DESIGN REVIEW COMMITTEE

June 15, 2022 6:00 PM

AGENDA

3330 Myrtle Street

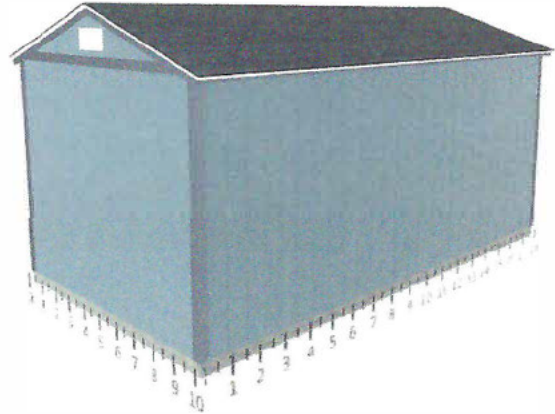
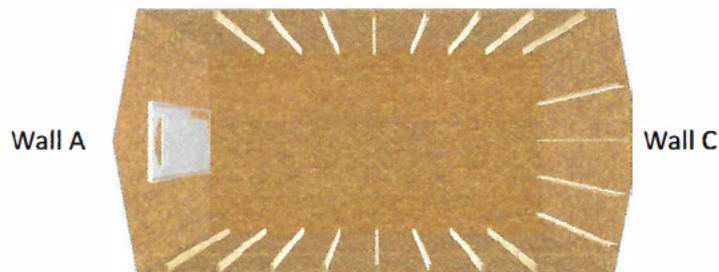
- The application whos lists wood siding. The siding should match the primary dwelling.
 - The proposed renderings show vertical siding compared to the lap siding on the dwelling.

1. The sketch is not clear regarding dimensions (specifically 29.3 ' – what does that refer to? Is the 29' the setback from the site property line?)
2. The proposed renderings show vertical siding versus lap siding used on the primary dwelling.
3. The height of the outbuilding has not been provided (14' min, 25' max).
4. The outbuilding must be placed on a permanent foundation – specs indicate dirt/gravel – this is not allowed per zoning code.
5. Only one accessory building is allowed per lot. It is not clear if any other buildings are present.
6. The building must be a minimum of 5' from the side property line and 10' from any buildings on adjacent lots. This is not confirmed.

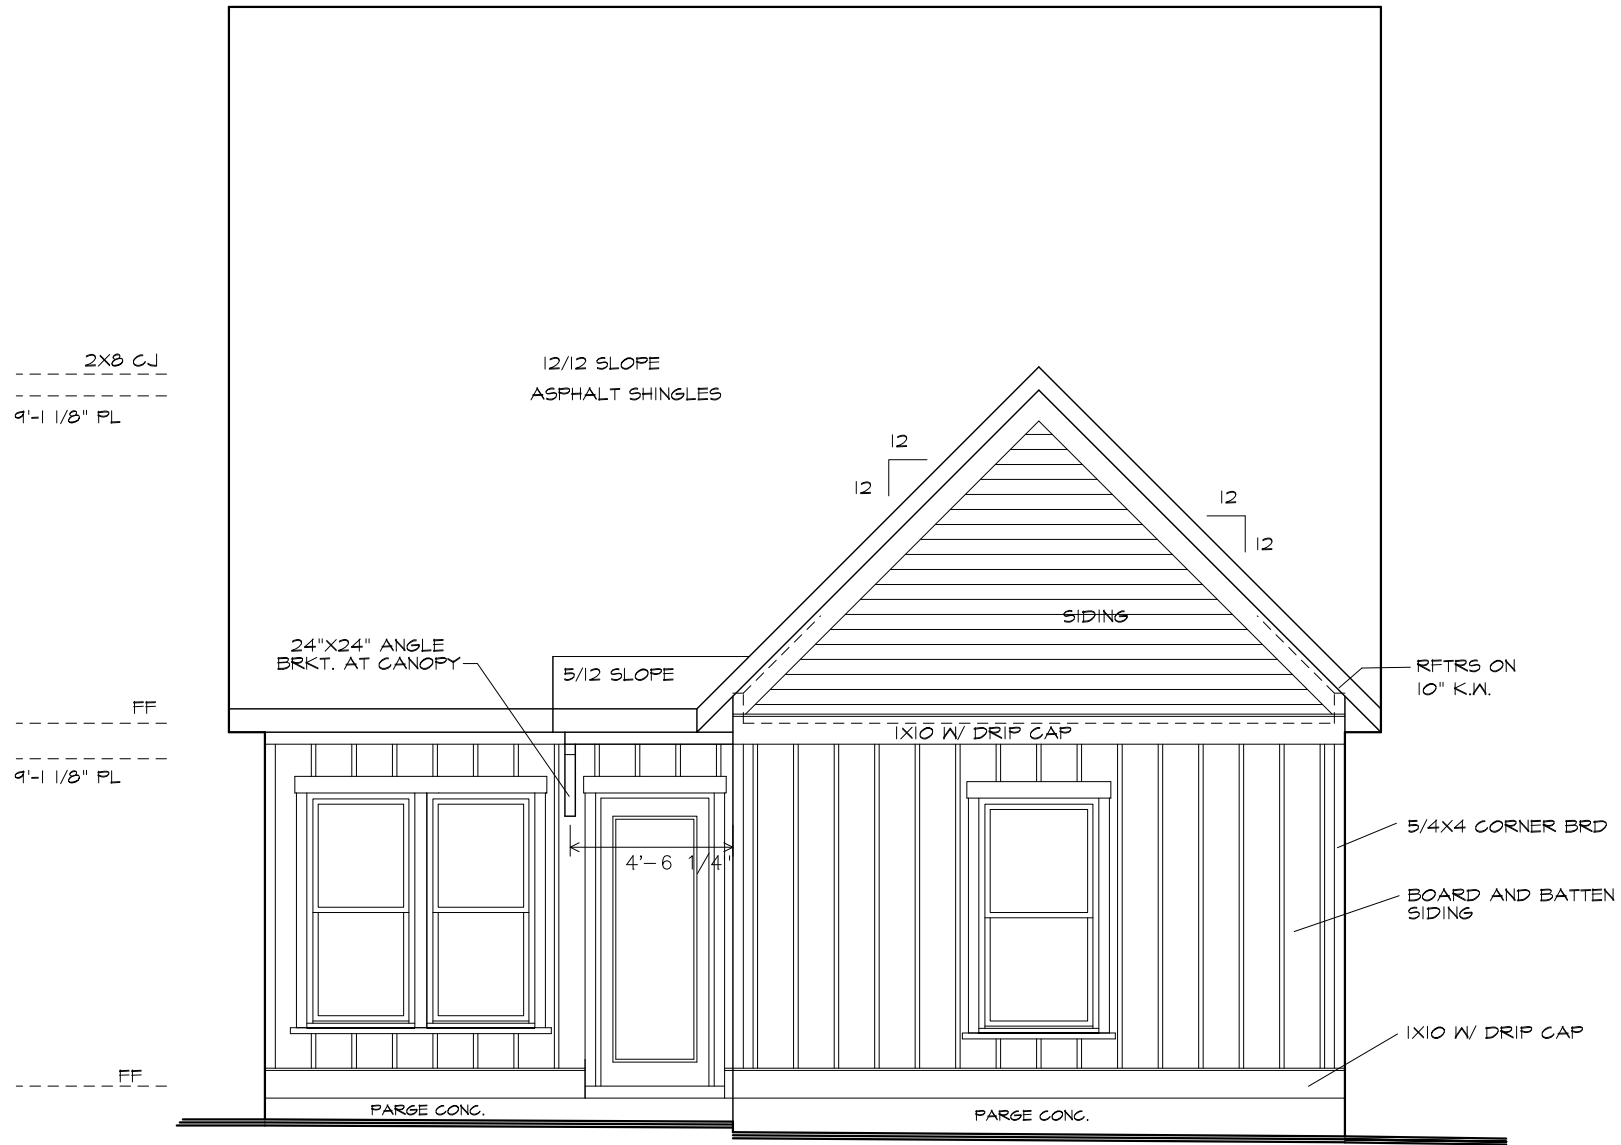
STAFF COMMENT: Ensure recess is a minimum of 2in on bottom sash. Windows shall be provided for a minimum of thirty (30) percent and a maximum of 50 percent of the total street-facing facade of the principal building, with each facade and story calculated independently. Building numbers not provided.
